Common Mode Comment Support

Richard Mellitz
Samtec

January 2022 IEEE 802.3ck Interim

CL 163 and Annex 120F transmitter test setup example

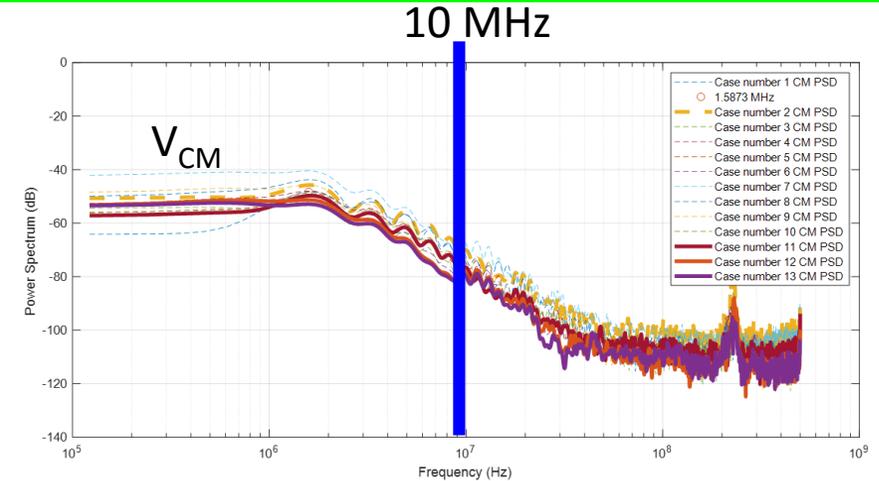
At some low enough frequency the common mode voltage at TPO and TP0v are approximately the same.

- $V_{CM}^{(tp0)} \cong V_{CM}^{(tp0v)}$

□ The TP0v CM specifications is:

- $SCMR = 20 \log_{10} \left(\frac{p_{max}}{V_{CMPP}} \right)$
- The parameter p_{max} is intended to adjust for high frequency fixture loss and **not relevant for low frequency signals**

□ **Recommend: Use V_{CMPP} only for a low frequency CM specifications.**

Proposal 1: Separate CM voltage specification by frequency

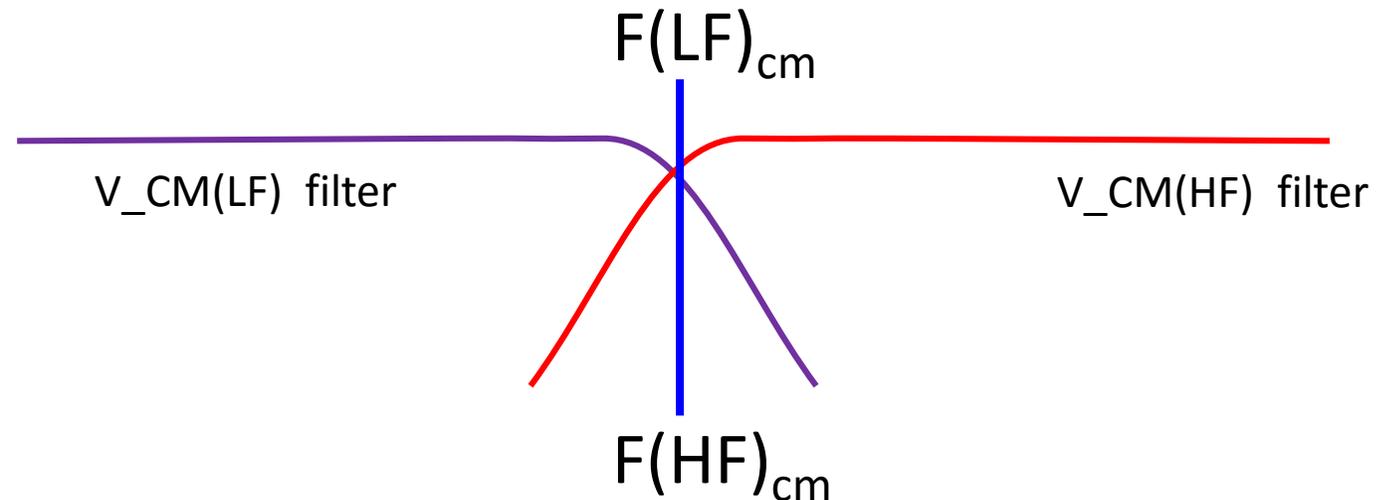
- ❑ $V_{CM}(LF)$ is V_{CM} filtered by a low pass 4th order Bessel Thomson filter with 3 dB point a $f(LF)_{cm}$
- ❑ $V_{CM}(HF)$ is V_{CM} filtered by a high pass 4th order Bessel Thomson filter with 3 dB point a $f(HF)_{cm}$
- ❑ OPTION 1
 - $F(LF)_{cm} = F(HF)_{cm} = 10$ MHz
- ❑ OPTION 2
 - $F(LF)_{cm} = F(HF)_{cm} = 100$ MHz
- ❑ Recommend option 1

Proposal 2: for CL 163 and Annex 120F

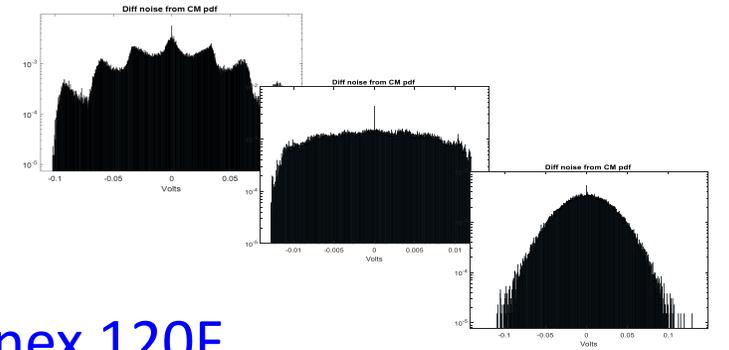
❑ Separate CM with filtering

- $V_{CM}(LF)$ is V_{CM} filtered by a low pass 4th order Bessel Thomson filter with 3 dB point a 10 MHz
- $V_{CM}(HF)$ is V_{CM} filtered by a high pass 4th order Bessel Thomson filter with 3 dB point a 10 MHz

❑ $V_{CMPP}(\max) \rightarrow 30$ mV (new line in tables)

- Used for low frequency

❑ SCMR(min) \rightarrow 11.8 dB (table 163-5) and 10.7 dB (table 120F-1)

- Used for high frequency
